**RESPONSE TO BRISBANE CITY COUNCIL INFORMATION REQUEST: S.13 OF THE *DEVELOPMENT ASSESSMENT RULES***

**DEVELOPMENT PERMIT FOR RECONFIGURATION OF A LOT (1 INTO 2 LOTS) OVER LAND AT 77 TELEGRAPH ROAD, BALD HILLS (LOT 9 ON RP77445).**

**COUNCIL REFERENCE: A006928760**

**Figure 4:** SFM-004 Brisbane Greenspace System Strategic Framework Map

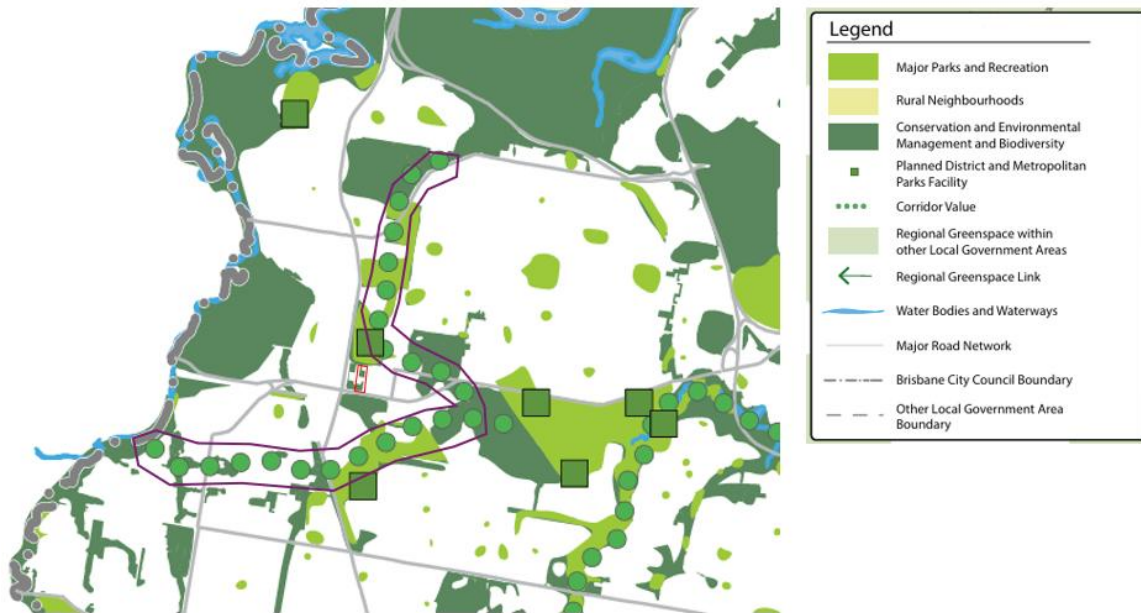
The Strategic Framework maps the valuable corridors across the city on SFM-004 Brisbane Greenspace System Strategic Framework Map. **Figure 4** extracts SFM-004 and highlights the site. The mapping that is identified over the site is otherwise reflective of the Biodiversity Areas Overlay Mapping. Based on SFM-004 the north-south corridor that has been asserted by Council as being of strategic value has not been reflected under the Strategic Framework. The corridor of value that has been mapped (circled in purple on **Figure 4**) is located to the east of the site not through the site as Council has asserted.
